PILOT BOARDING DEFICIENCY REPORT

DATE: JAN 13, 2020 TIME: 17:20

VESSEL: ANDIMILOS

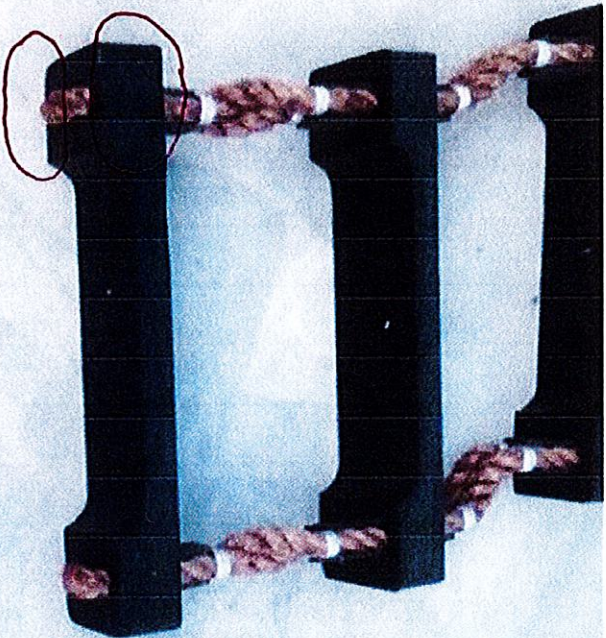
1) BOTTOM MOST STEP WAS BROKEN AND NOTHING PREVENTING ONE SIDE FROM FALLING OUT

2) RIGHT SIDE OF LADDER LOWER THAN LEFT RUNGS WERE NOT EVEN

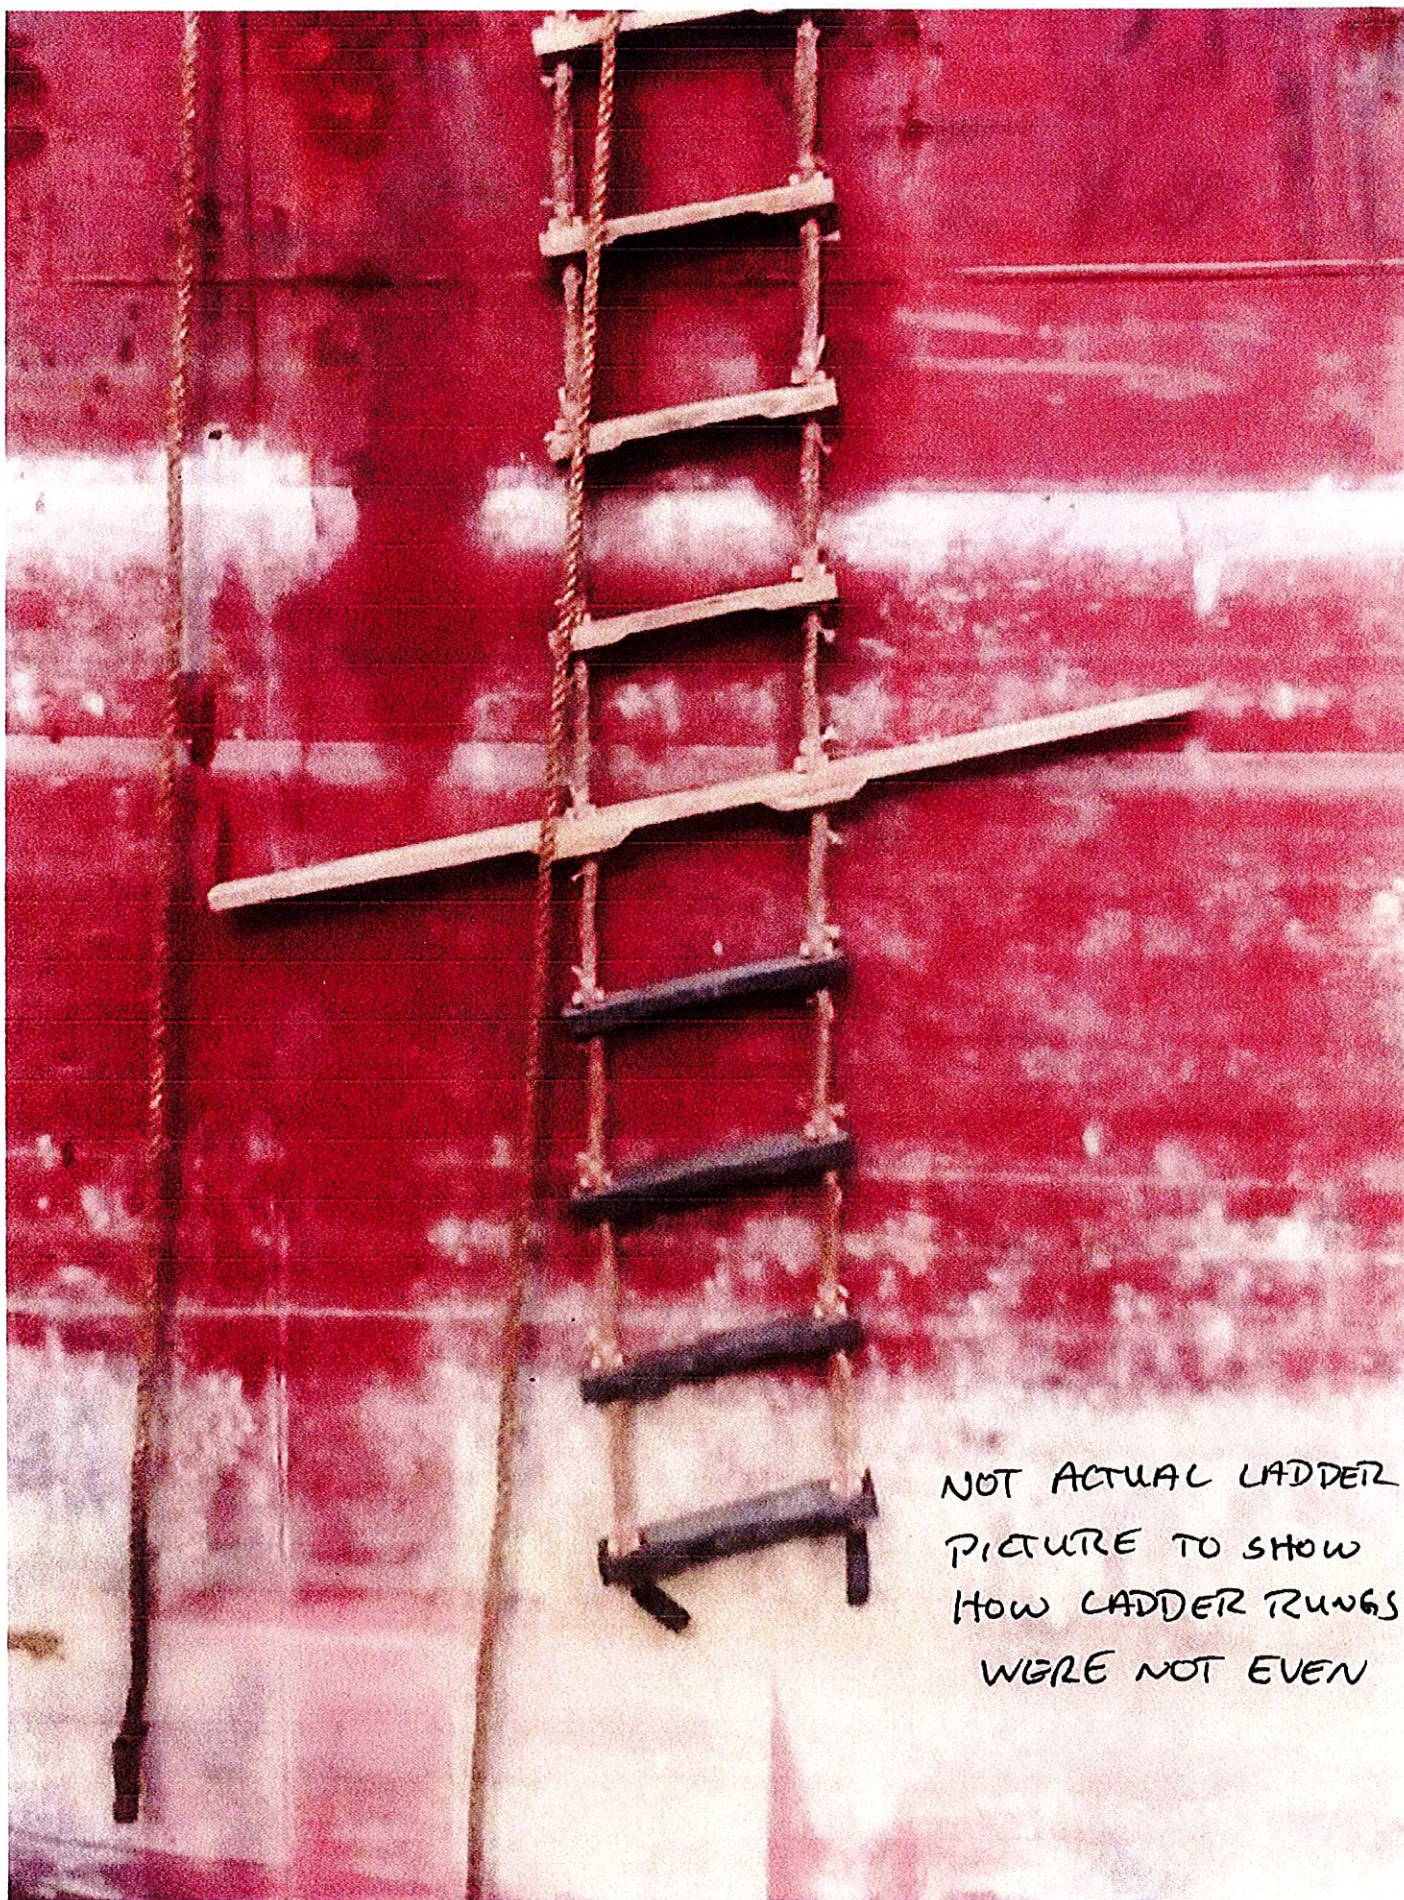
BLACK CORNERS
ON RUNS ON
BOTTOM STEP
MISSING. NOTHING
PREVENTING STEP
FILM COMING OUT
OF SLICE

NOT ACTUAL CAMERA (PICTURE USED
TO DESCRIBE DEFICIENCY)

NOT ACTUAL LADDER
PICTURE TO SHOW
HOW LADDER RUNGS
WERE NOT EVEN
